# Access Compliance Report

### (Curb Ramps)

Intersection ID: 52306	Main Street: IMPATIE_N_DR	Cross Street: AMERIA_RD	Location: NW
ADA ID: 4F7916EEA40D	Ramp Type: PerpDiag	Initial Pass/Fail: Fail	Overall Compliance: No
Severity Score: 8.75			
Codes/Mitigation Info/Possible Solution		Field Measurements/Component Compliance

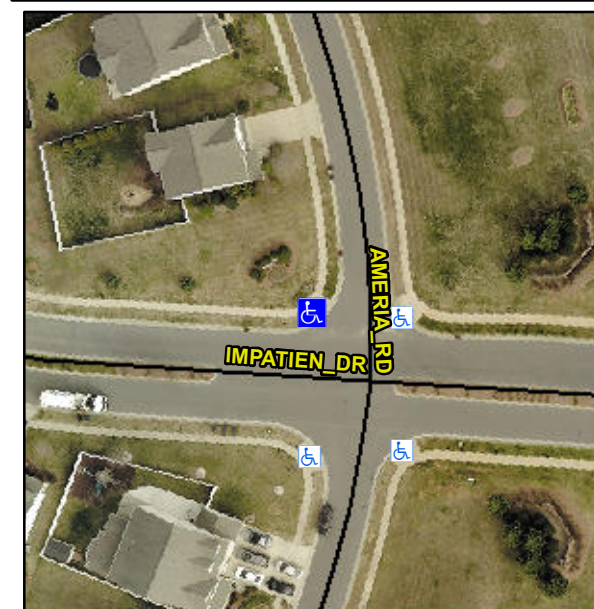
**Not Found, R304.5.1**

Compliance	Description	Data	Compliance	Description	Data
N/A	Ramp Length (in)	73.5	Yes	Ramp Slope (%)	5.5
No	Ramp Width (in)	46.5	Yes	Ramp XSlope (%)	1.7
N/A	Flare Type LT	N/A	N/A	Flare Type RT	N/A
N/A	Flare Slope LT (%)	N/A	N/A	Flare Slope RT (%)	N/A
N/A	Flare Traversable LT?	N/A	N/A	Flare Traversable RT?	N/A
N/A	Landing Length (in)	N/A	N/A	DWS Provided?	N/A
N/A	Landing Width (in)	N/A	N/A	DWS Contrast?	N/A
N/A	Landing Slope (%)	N/A	N/A	DWS Length (in)	N/A
N/A	Landing X Slope (%)	N/A	N/A	DWS Full Width?	N/A
N/A	Landing Curb? (Y/N)	N/A	N/A	DWS Offset (in)	N/A
N/A	Shared Landing?	N/A			
N/A	Gutter Ponding?	N/A	N/A	Gutter Slope (%)	N/A
N/A	Gutter Lip Ht (in)	N/A	N/A	Gutter X Slope (%)	N/A
N/A	Painted X Walk1?	No	N/A	Painted X Walk2?	No
	X Walk 1 Direction	To S		X Walk 2 Direction	To E
N/A	X Walk 1 Width (in)	N/A	N/A	X Walk 2 Width (in)	N/A
	X Walk 1 Slope (%)	2.0		X Walk 2 Slope (%)	0.8
	X Walk 1 X Slope (%)	0.4		X Walk 2 X Slope (%)	1.5

**Remove & Replace Curb Ramp With Two New Directional Ramps or Equivalent.**
